Inspection Photos

Location Name: Logos Operating LLC. – Northwest Cedar Hill 32-10API # 05-067-05010

Inspection Doc #: 721100095

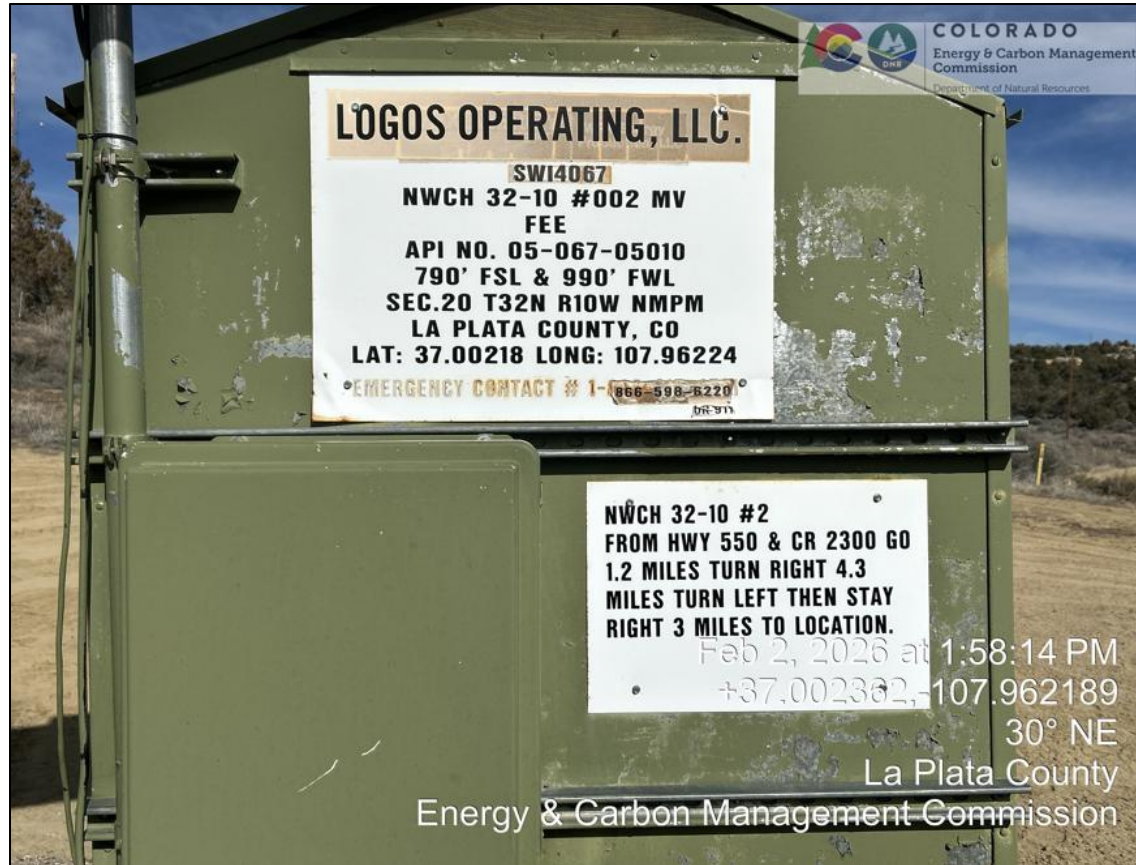
01 – Well Sign posted on side of meter run shed. Note that 24 hour and emergency contact numbers are getting very difficult to read.
